Rezoning Transportation Analysis

Petition Number: 2021-092

| Date | Description |
|------------|--------------------|
| 06-01-2021 | First Review (KP) |
| 08-23-2021 | Second Review (KP) |

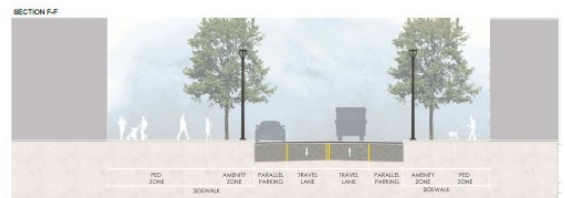
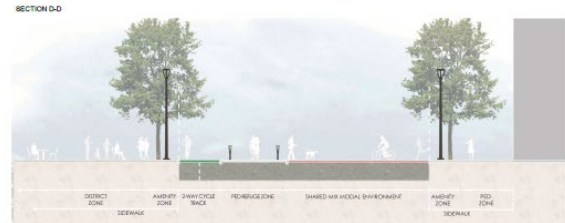
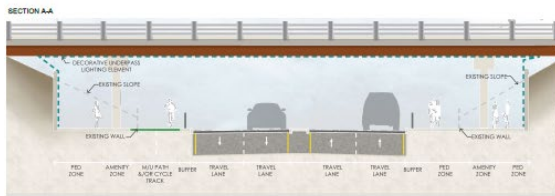
- b. ~~McDowell Street: 110 feet of total right-of-way dedication, 55 feet measured from the existing road centerline to each right-of-way line.~~
- c. ~~Baxter Street (Section C-C) — 93 feet of total right-of-way dedication, 46.5 feet measured from the existing road centerline to each right-of-way line.~~
- d. ~~Baxter Street (Section D-D) — 86 feet of total right-of-way dedication, 43 feet measured from the existing road centerline to each right-of-way line.~~
- e. ~~Baxter Street Extension (Section E-E) — 93 feet of total right-of-way dedication, 46.5 feet measured from the existing road centerline to each right-of-way line.~~
- f. ~~Proposed Public Street (Section F-F) — 73 feet of total right-of-way dedication, 36.5 feet measured from the existing road centerline to each right-of-way line.~~

The proposed and existing Morehead Street right-of-way dedication must be labeled dimensioned from the existing centerline.

Sheet RZ-1.1 – Typical Sections

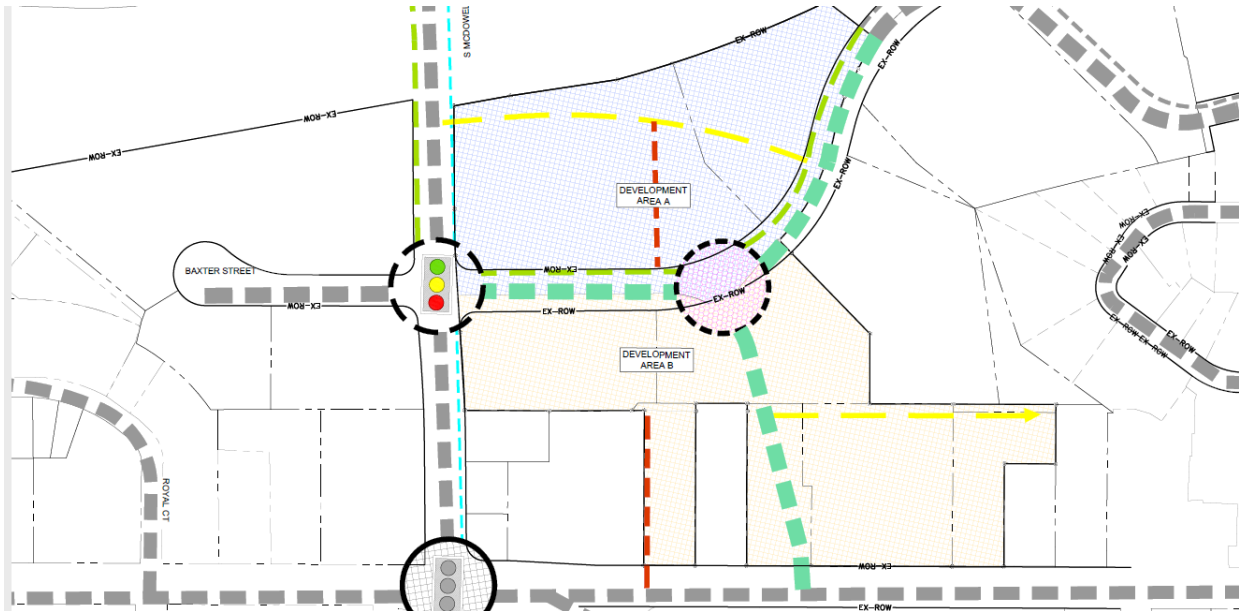
1. ~~**Curb line:** The proposed zoning district has a setback measured from back of the existing or proposed future curb line. Revise Sheet RZ-1.1 by adding the curb line dimensions to the cross sections provided. Please note: The following curb line dimensions proposed are conceptual and may be altered as coordination with CDOT throughout the rezoning process ensues.~~

The proposed and existing back of curb location on Morehead Street must be labeled dimensioned from the existing centerline.

3. ~~**Right of way and Other Infrastructure Dimensions:** Revise Rezoning Sheet RZ-1.1 to include detailed dimensions for each infrastructure item, and the total right-of-way for the cross sections shown. Refer to the USDG Cross sections and on-street parking details, located within the Charlotte Land Development Standards Manual, to determine the appropriate widths associated with each infrastructure item and the cross sections' total widths. Revise the site plan sheets by clearly labeling each public and private street section as well as each access point. Labeling each street section and access point will allow for thorough comments throughout the rezoning and permitting process. CDOT prefers the separated cycle track and sidewalk for McDowell Street (cross sections A-A and B-B). Please note: The following right of way dimensions proposed are conceptual and may be altered as coordination with CDOT throughout the rezoning process ensues.~~

Sheet RZ-1.3 – Ped and Bike Connectivity

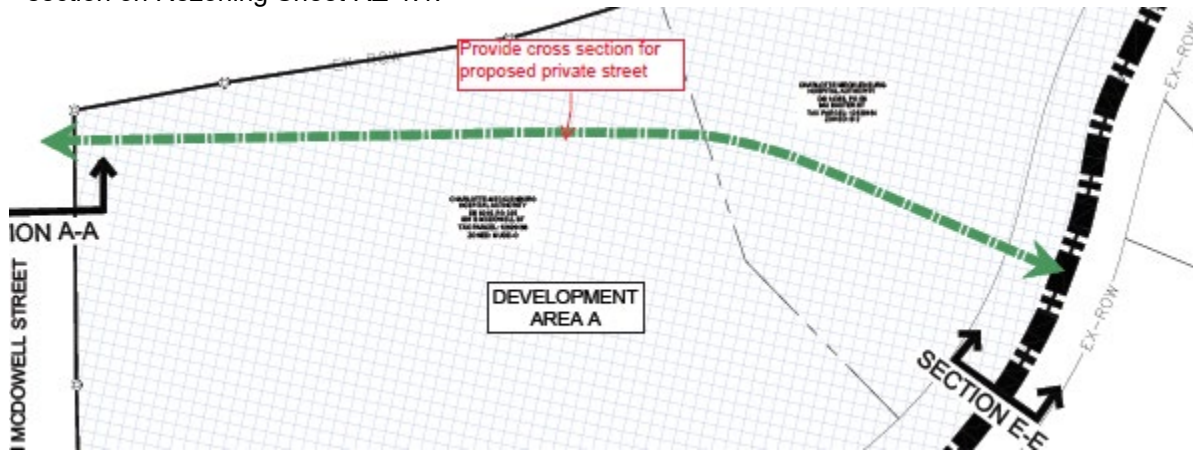
4. ~~Revise the Rezoning Sheet RZ-1.0 and RZ-1.1 by establishing a cross section associated with the proposed private street connecting McDowell Street to Baxter Street Extension. Include the cross section on Rezoning Sheet RZ-1.1.~~

5. ~~Revise the site plan sheets and conditional notes by committing to connect the roadway improvements, pedestrian improvements, and the proposed cycle track associated with the Baxter Street Extension, Cross Section E-E, to the relative infrastructure associated with the Pearl Parkway Extension, SDRMUR-2020-00026.~~
